Report to Planning and Environment Committee

Subject: 489 Upper Queen Street
Public Participation Meeting
City File No: Z-9540 Ward 12

Date: January 30, 2023

Figure 3: Revised Site Plan (Second/Final Submission)

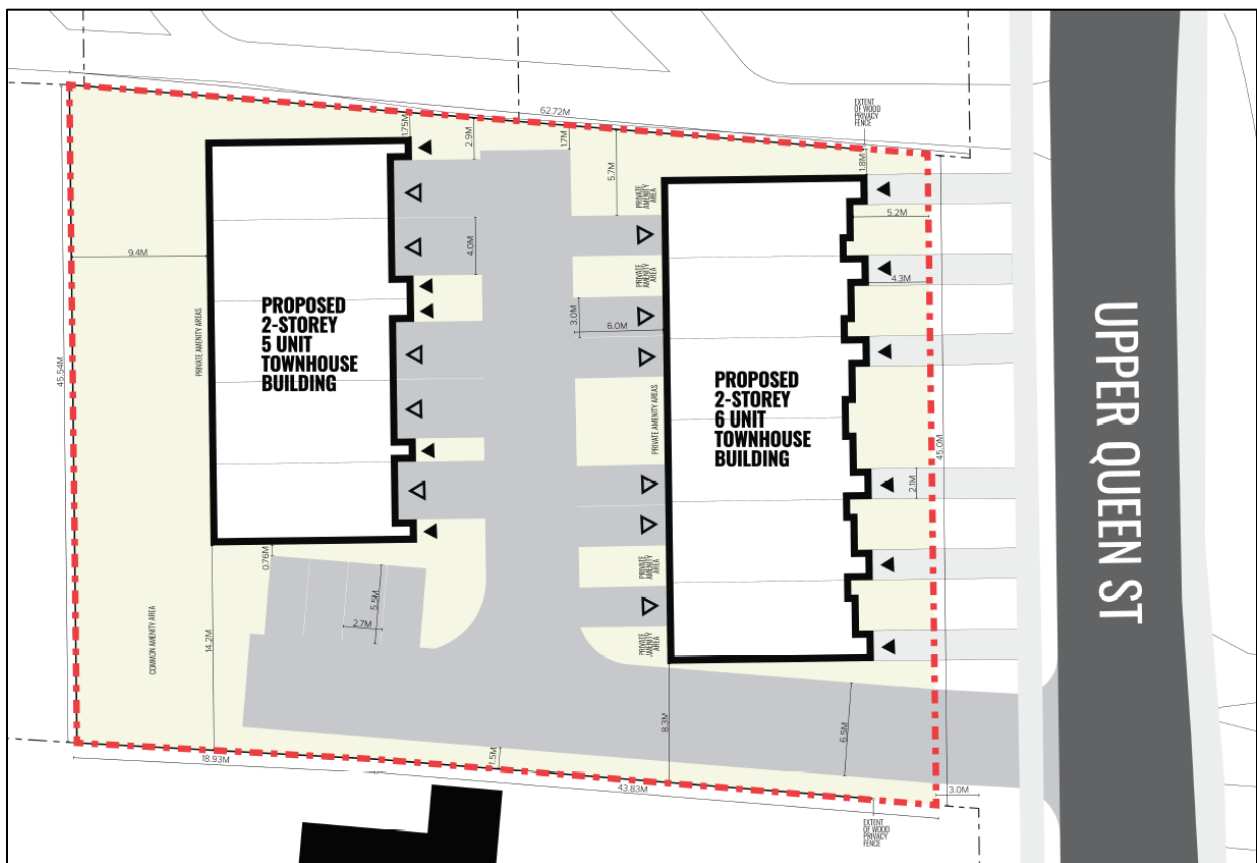
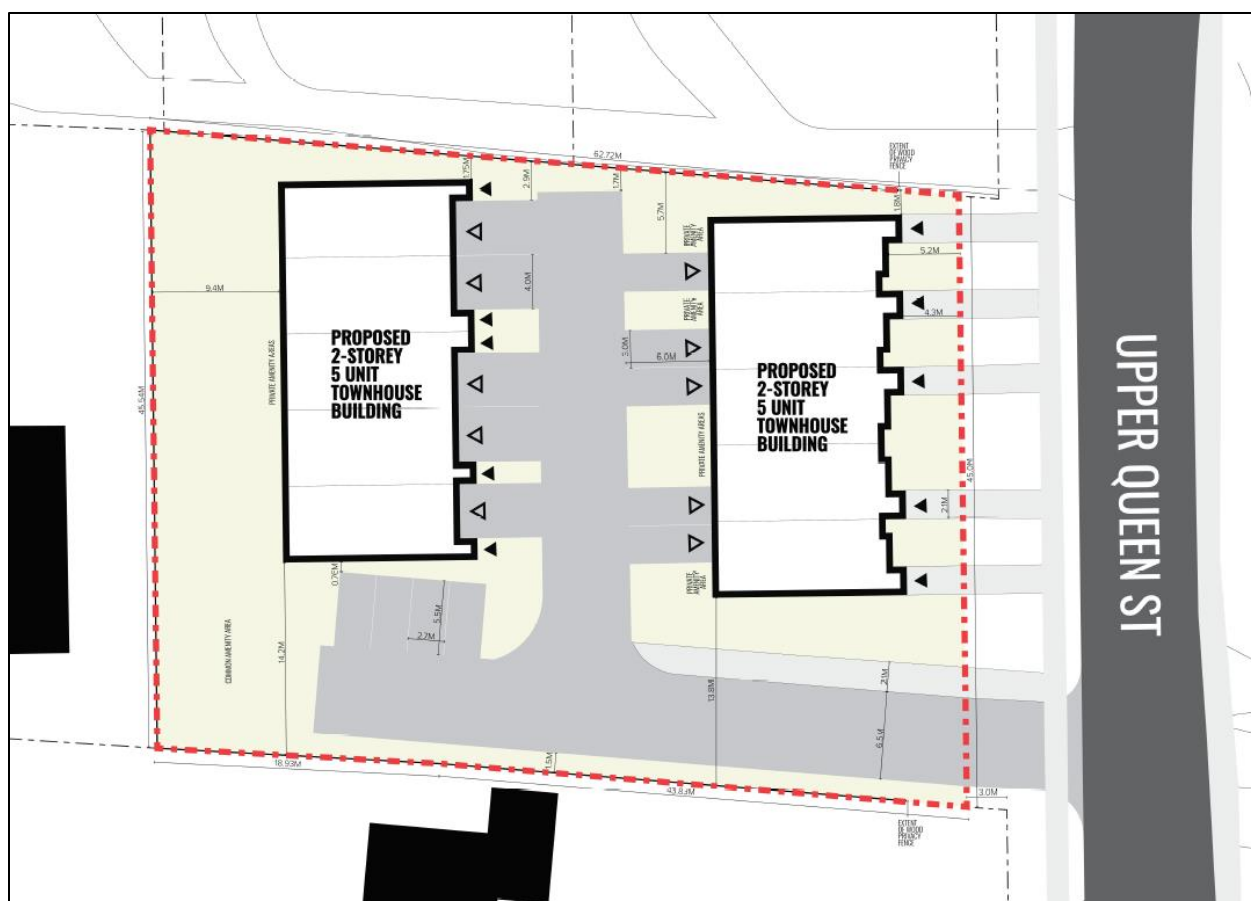
In response to Planning and Development, Site Plan, and Urban Design staff comments, the Applicant submitted a revised site concept plan to staff illustrating the following changes to the proposed site design:

First Submission (November 21, 2022)	Second Submission (December 19, 2022)
<ul style="list-style-type: none"> • 11 townhouse units (5 in the rear and 6 oriented towards Upper Queen Street) 	<ul style="list-style-type: none"> • 10 townhouse units (5 in the rear and 5 oriented towards Upper Queen Street)
<ul style="list-style-type: none"> • No dedicated pedestrian walkway from Upper Queen Street through the site. 	<ul style="list-style-type: none"> • Removal of the southerly most unit in the front row has allowed for a dedicated pedestrian walkway through the site

- S6.2,Proposed Development Concept,
- Site Access and Circulation Plan

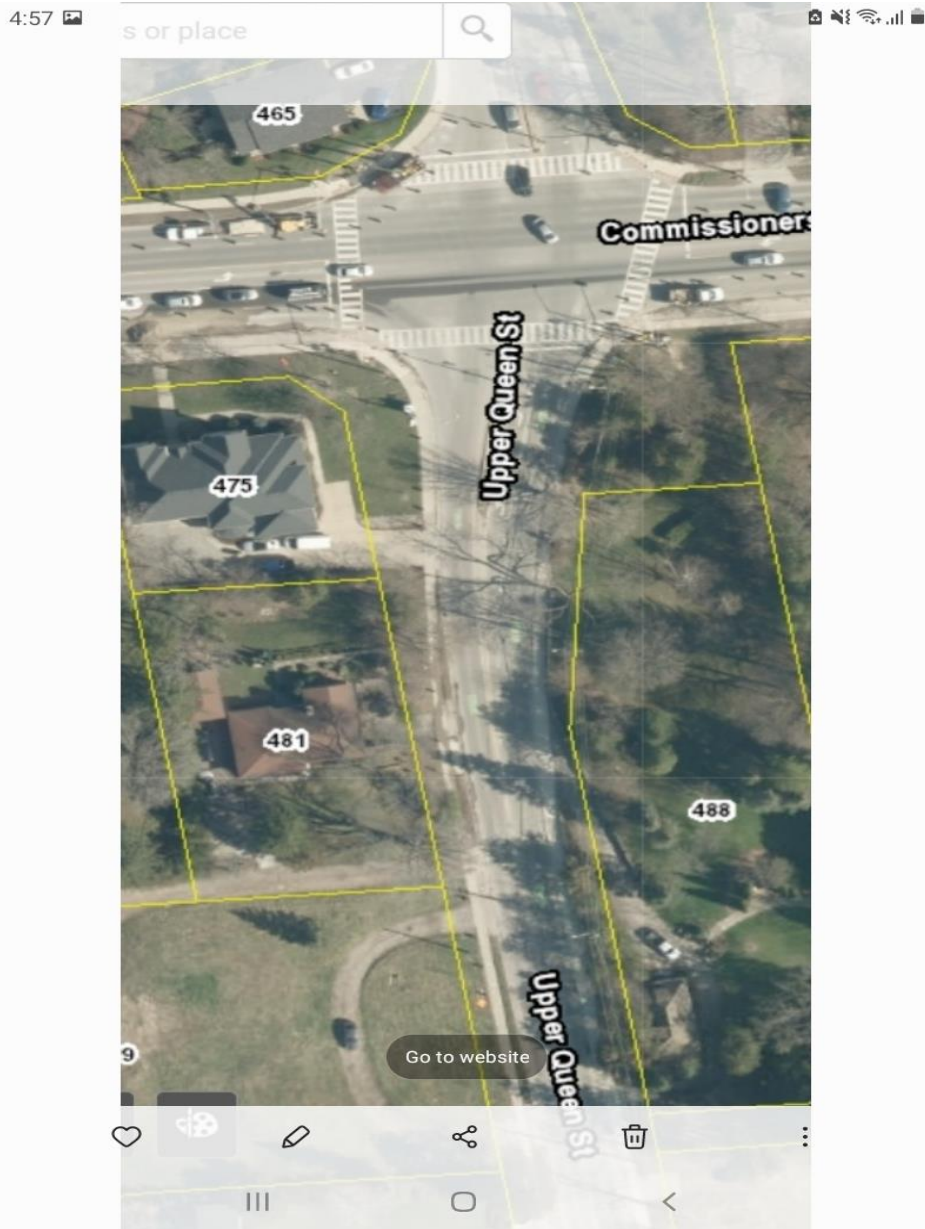
This design graphic indicates a double driveway for incoming and outgoing traffic for the site. This design graphic indicates that outgoing traffic will turn either right or left onto Upper Queen Street.

This design indicates traffic turning into property from Upper Queen Street from both north and south.

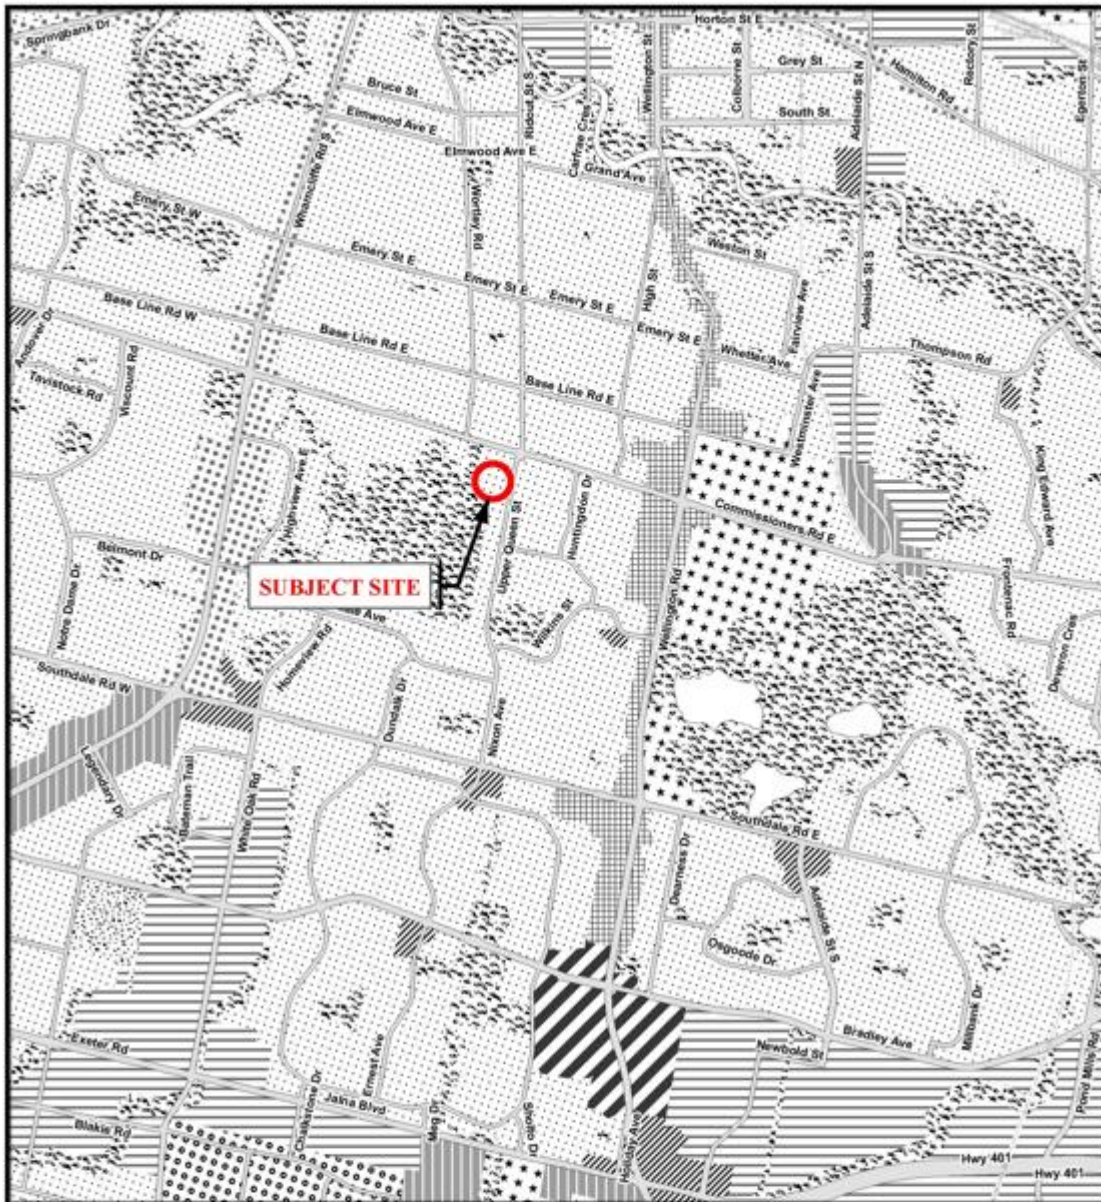
Please see below for UD comments related to the planning application at **489 Upper Queen St.** Many of these comments were provided at SPC but were not addressed through this process.

- Provide a pedestrian connection from the city sidewalk to the front entrances of the rear units as well as the common amenity space.
- Remove a unit from each of the townhouse blocks to allow for the pedestrian connection and a buffer between the drive aisle/parking area and the townhouse building edges.
- Reduce the driveway and garage widths for the rear units to not exceed 50% of the unit façade width.
- The applicant is to submit a completed “Urban Design Peer Review Panel Comments – Applicant Response” form that will be forwarded following the UDPRP meeting scheduled for September 2022. This completed form will be required to be submitted as part of a complete application.
